SUBJECT: CATAWBA NUCLEAR STATION, UNITS 1 AND 2 (CATAWBA 1 AND 2),  
MCGUIRE NUCLEAR STATION, UNITS 1 AND 2 (MCGUIRE 1 AND 2), AND  
OCONEE NUCLEAR STATION, UNITS 1, 2, AND 3 (OCONEE 1, 2, AND 3) –  
PLAN FOR THE REGULATORY AUDIT REGARDING LICENSE AMENDMENT  
REQUEST FOR ALTERNATE FISSION GAS GAP RELEASE FRACTIONS  
(CAC NOS. MF6480, MF6481, MF6482, MF6483, MF6484, MF6485, AND  
MF6486)

AUDIT REPORT BY THE OFFICE OF NUCLEAR REACTOR REGULATION

RADIOLOGICAL SOURCE TERM GAP FRACTIONS

Figure 2: I-131 Gap Fraction Comparison, FRAPCON 4.0 versus "gapfrac" macro

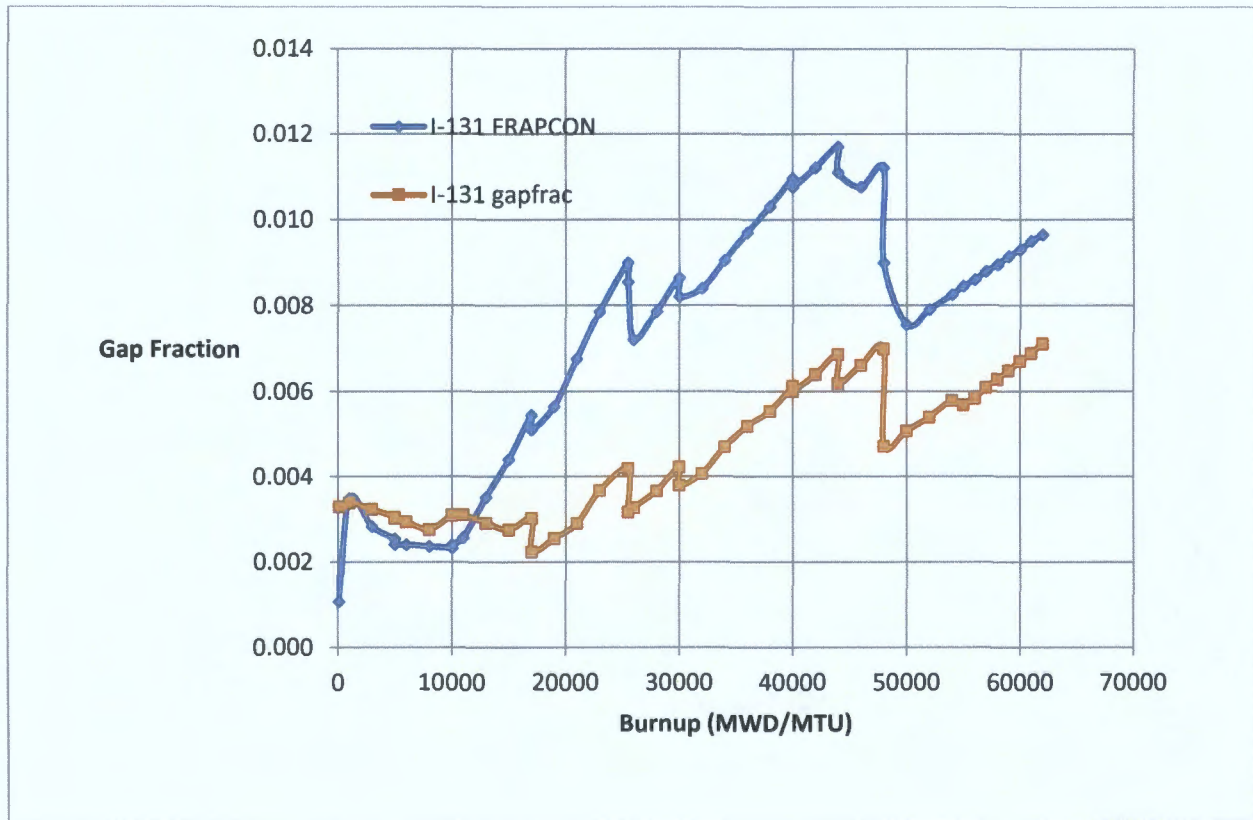
Figure 2 shows the difference between the short-lived I-131 release-to-birth ratio (R/B) predicted by the 'gapfrac' macro and FRAPCON 4.0. A multiplier of 5.0 was consistently applied to the COPENIC and FRAPCON Kr-85m R/B predictions in accordance with the ANS-5.4 (2011) standard. Examination of Figure 2 reveals similar trends in predicted R/B for the short-lived I-131 isotope.

Figure 3: Comparison of Rod Power Histories

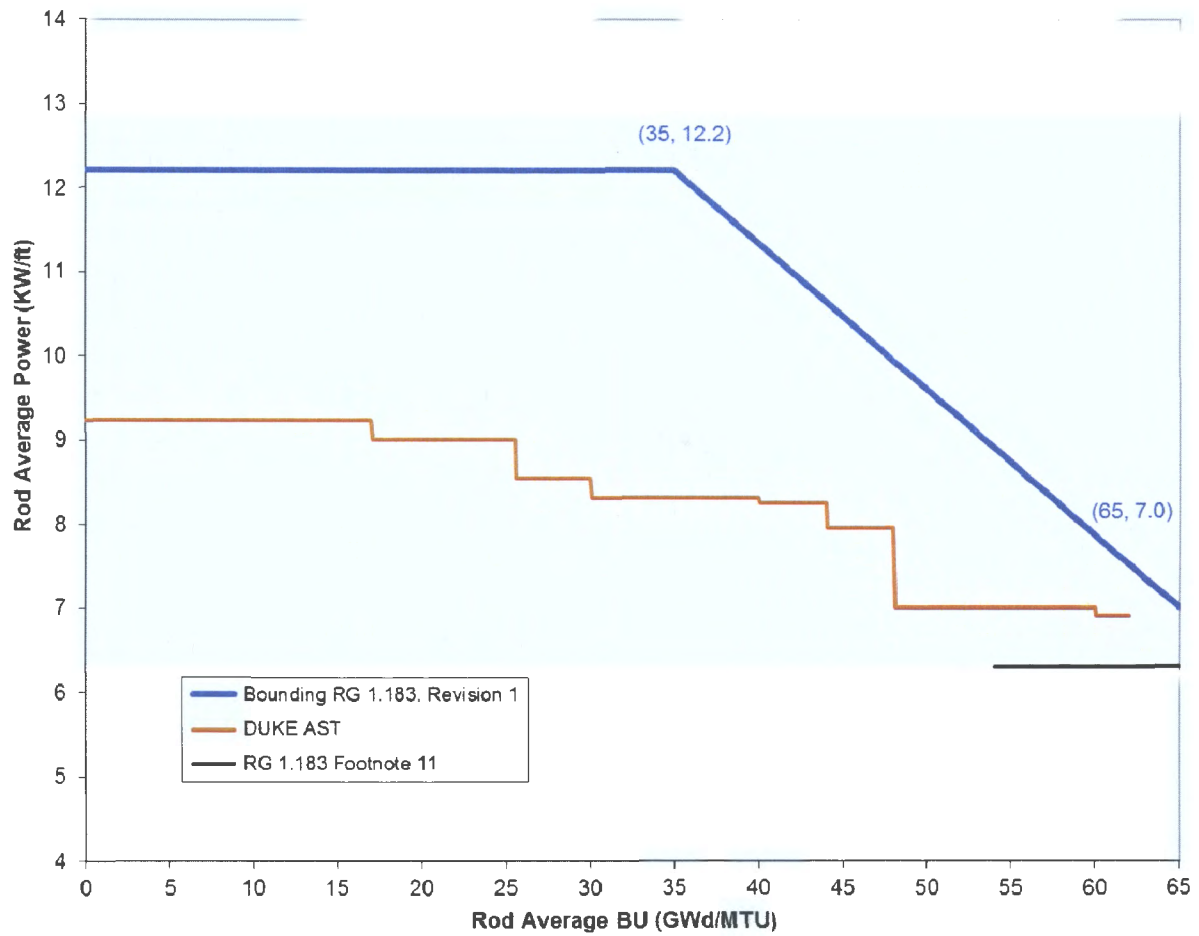
Table 3 provides a comparison of the original and revised gap fractions along with the Duke proposal. Figure 3 provides a comparison of the rod power histories used to develop the different gap fractions. Application of the 2011 ANS-5.4 standard provides significant benefit (i.e., lower R/B) for the short-lived isotopes for a given rod power history. For setting the power history envelope of Reference 3, the NRC staff elected to expand the rod power history until the target 8.0% I-131 was achieved. Hence, using the beneficial reduction in short-lived isotope releases afforded by the ANS-5.4 (2011) standard. The result is an expanded operating domain relative to Footnote 11 in RG 1.183 Revision 0.

For each radionuclide, Duke Energy has elected to select the larger value calculated using ANS-5.4 (1982) and ANS-5.4 (2011). This approach is clearly conservative. Examination of Figure 3 reveals that the Duke Energy allowable rod power history is much more benign than the rod power envelope in Reference 3. Yet, the predicted I-131 is twice as large (2x multiplier on 8.0%). This is attributed to the differences between ANS-5.4 (1982) and ANS-5.4 (2011). For the long-lived isotopes (Kr-85 and Cesium), the Duke Energy proposed gap fractions are smaller than those in the bounding case of Reference 3. This is directly related to the more restrictive rod power envelope.
